Our Ref: 70032760/ob/CP_ds

17 July 2020

Land East of Boothstown Technical Support – Drainage and flood Risk

Figure 1- Extract from JBA modelling (SFRA draft flood mapping - JBA 2019)
(WSP annotated with route of Shaw Brook)

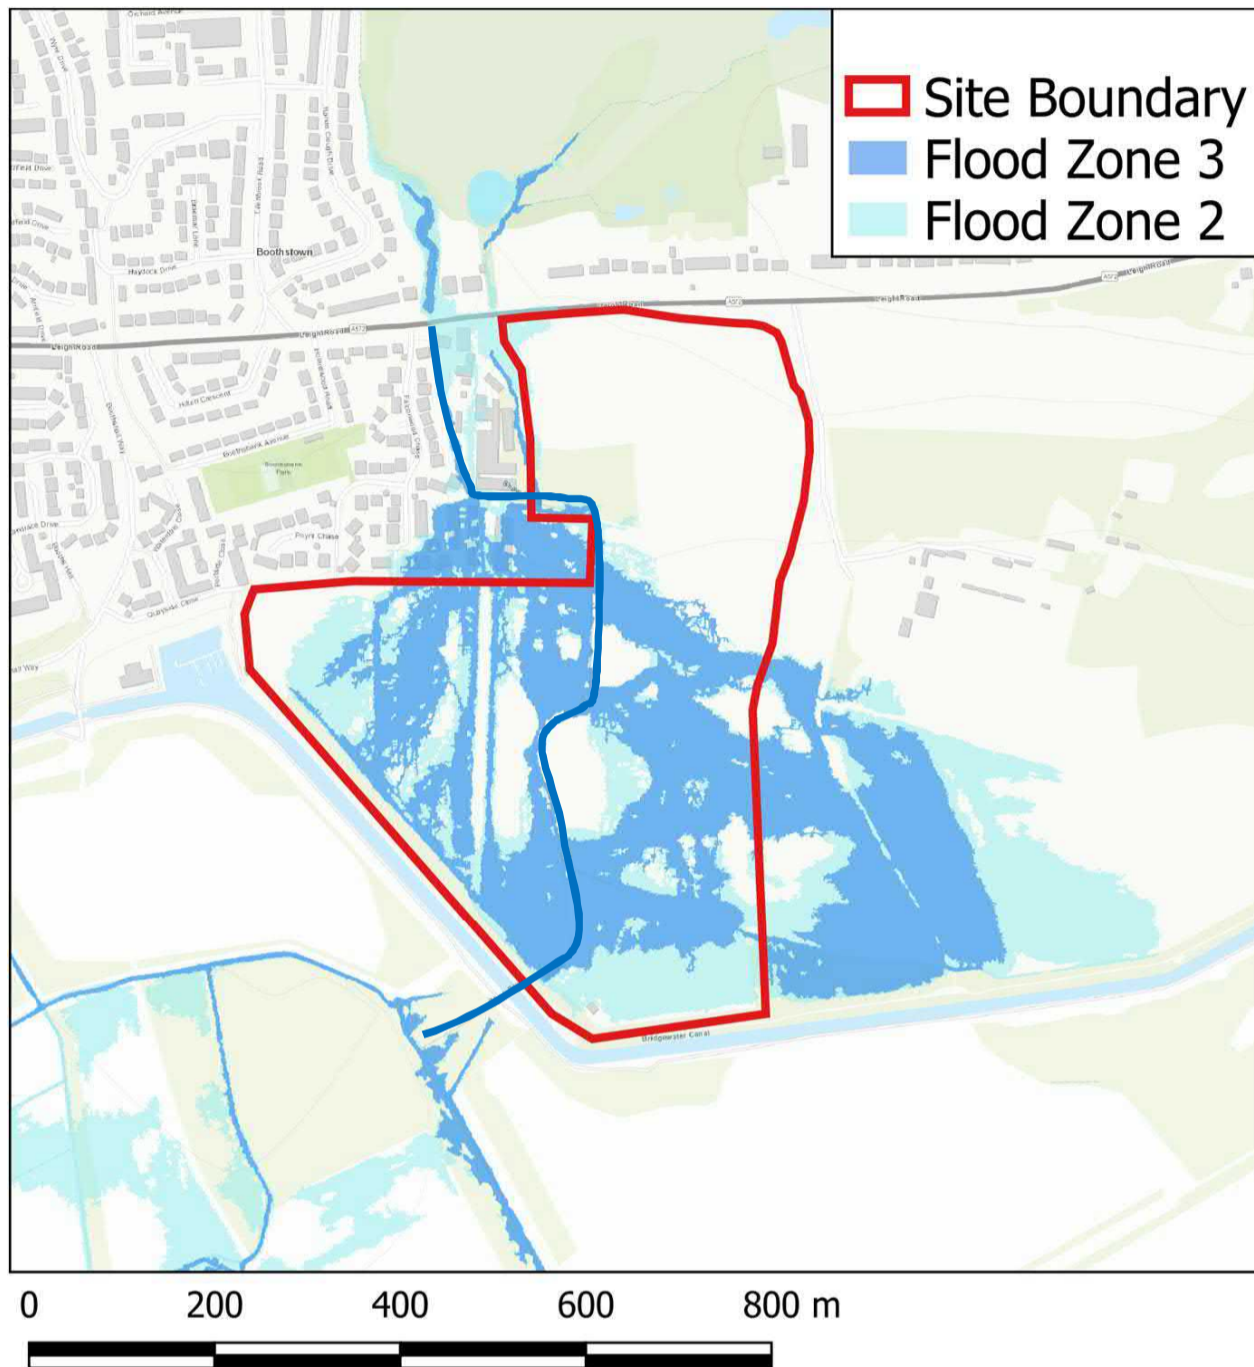
Shaw Brook is partially culverted within the site to allow access to the surrounding fields and this has been included in the recent modelling, but survey information suggests that some of the JBA modelling assumptions have been conservative on the state and size of the culverts. This has a direct impact on calculating the out of bank threshold and hence the volumes and areas impacted. As stated above, this note is considering the state as currently shown. More detailed modelling and survey work will need to be undertaken to verify the site conditions. **Figure 1** below is the recent modelling supplied by JBA as considered to date and within this note.

It is noted that the out of bank element spills out of Shaw Brook quite high in the system. This equates to the location of existing culverts (i.e restrictions to the Shaw Brook flow). These are also highlighted on the topographical plan contained as **Appendix A**. In general, once overtopped the flows follow the topography of the site and in many cases re-enters Shaw Brook further to the south.
